Resolutions to Comments Discussed at Taipei Meeting

Summary of Comments from TG3c meeting

In this document we present the responses to open comments from TG3c meeting in Taiwan. This document will focus on comments except beamforming, stream index and preamble design, which will be finalized during Orlando meeting. We present 22 resolutions out of 33 technical comments and 4 out of 7 editorial comments. The summary of comments and our responses are given below. Resolutions related to PHY start from slide 3 and related to MAC from slide 21.

Comment Number #20 (6/10)

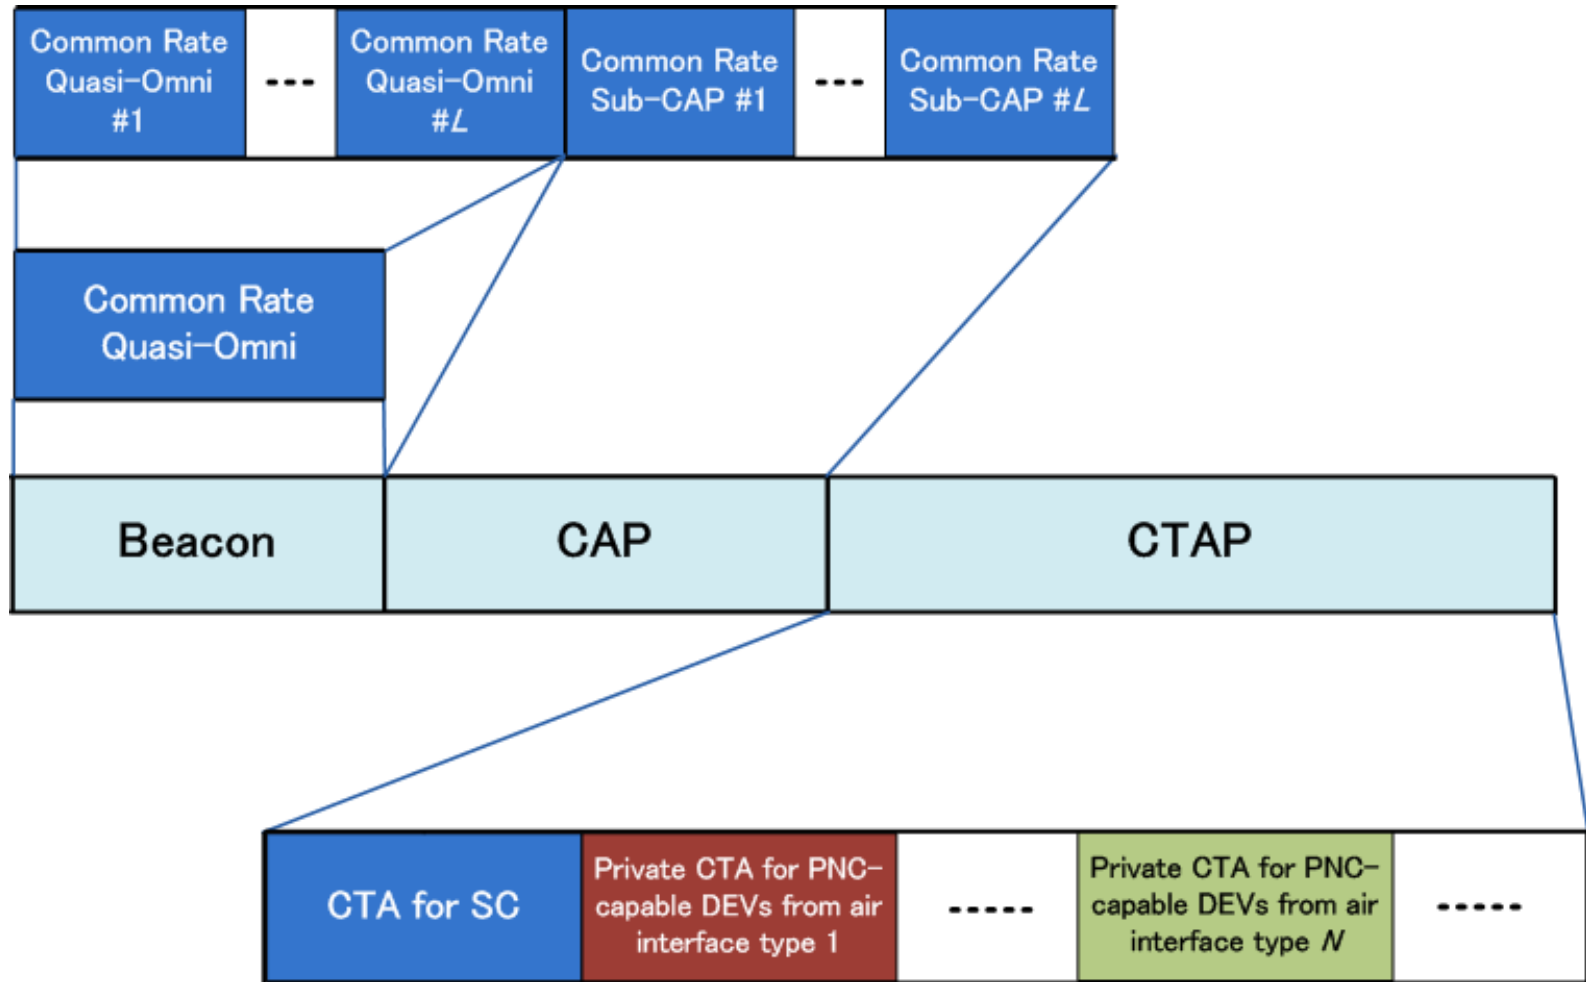
- Common Rate shall be mandatory for Super-PNC
- Common Rate is mandatory for SC DEVs and optional for OFDM DEVs
- A non-SC PNC-capable DEV **has to support Common Rate** if it wishes to communicate with Super-PNC

Effect of different resolution value (3/7)

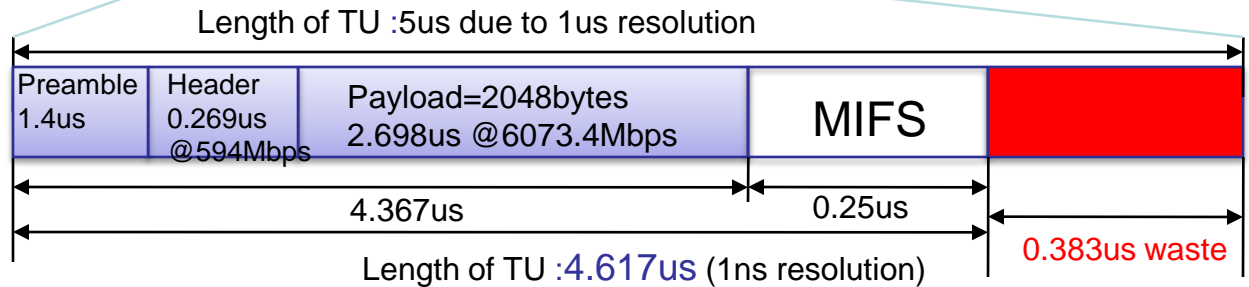
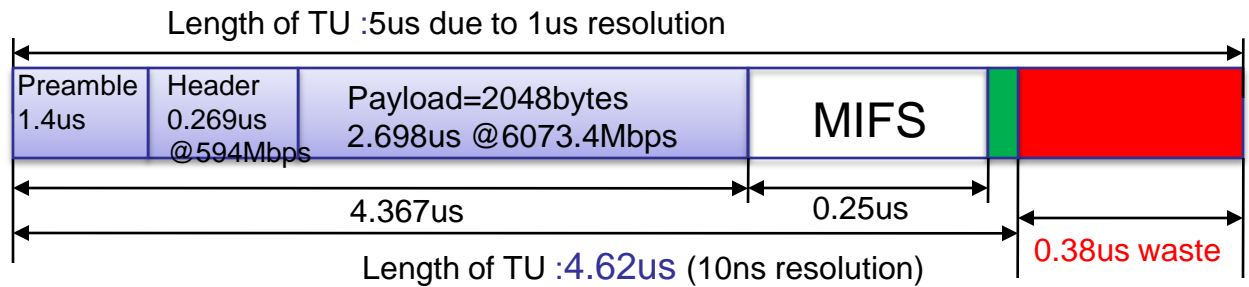
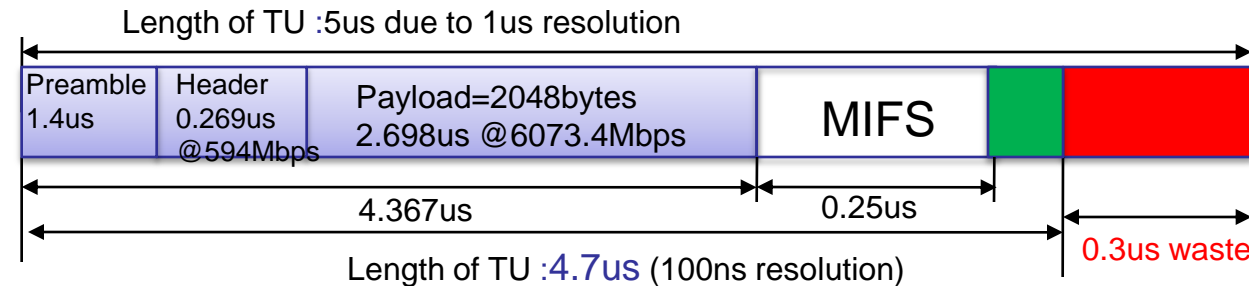
- Comment
 - Does the resolution of the superframe timing need to be less than $1\ \mu\text{s}$?”
- Resolution
 - Yes. $1\ \mu\text{s}$ superframe resolution should be changed to $10\ \text{ns}$ for the sake of up to $14\ \%$ throughput improvement with $2\ \text{Kbytes}$ data transmission at $6\ \text{Gbps}$ PHY-SAP
 - The corresponding overhead in beacon is less than $1\ \%$ against superframe length, which is ignorable

$$R1 = 0.383/5 = 7.66\%$$

$$R2 = 0.383/2.698 = 14.2\%$$

$$R1 = 0.38/5 = 7.6\%$$

$$R2 = 0.38/2.698 = 14.1\%$$

Comment # 11

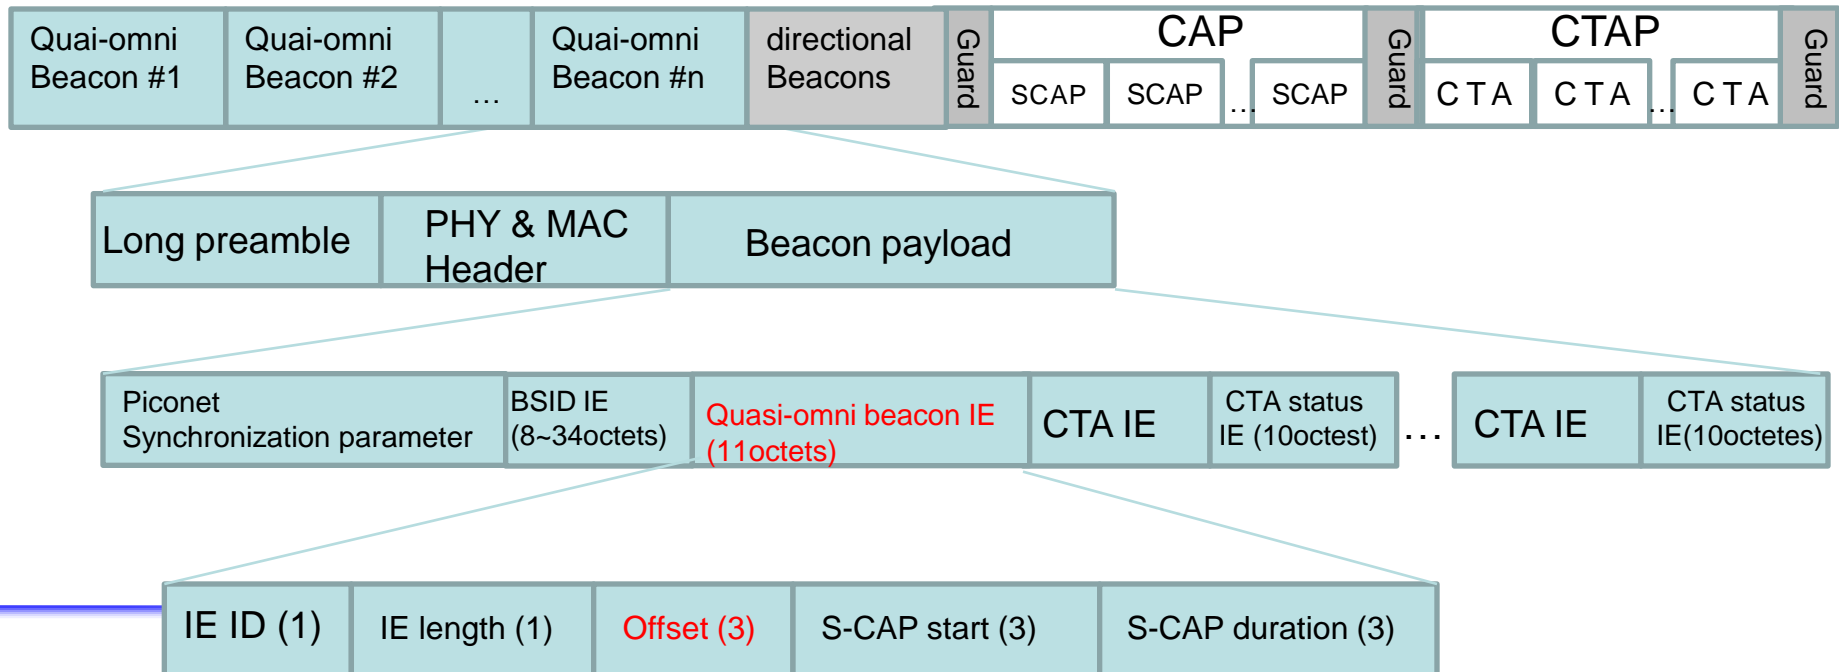
- Comment
 - How do DEVs know when the superframe starts and when the last beacon ends if they receive one beacon in the middle of a set of beacons.
- Resolution
 - Quasi-omni beacon IE is defined to indicate the offset from the start of the superframe to the first symbol of the current received beacon

Use 802.15.3 probe command for UEP information exchange

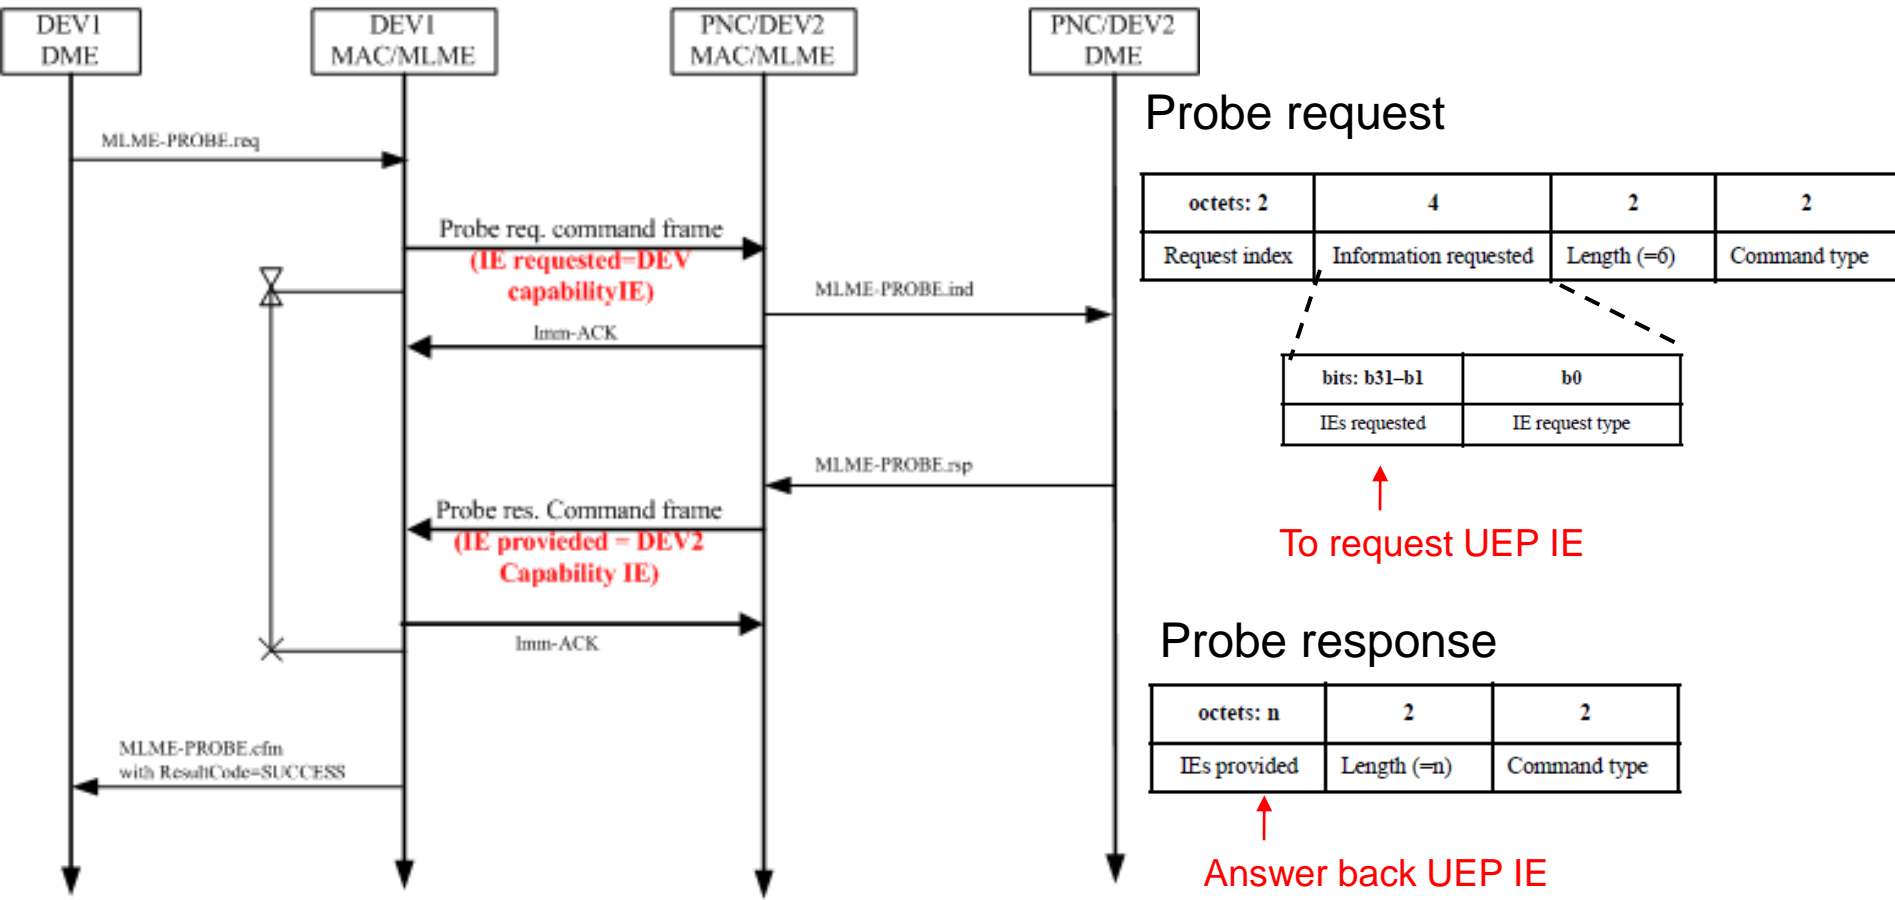
- Comment #17
 - Can this be done with an information element? Also, there are some updates to the frame format that need to be reviewed.
- Resolution
 - Yes, rather than creating new command frame, UEP (TBD) IE can be exchanged for the same purpose. This issue is related with Comment #36
- Comment #36
 - Rather than using commands, if the UEP capabilities are exchanged as part of the normal capabilities exchange, then the commands are not needed.
- Resolution
 - That is right. 802.15.3 already has the peer discovery function (use probe command) which can be used to exchange UEP information. What needed is just to exchange UEP (TBD) IE between DEVs which have intention of UEP streaming
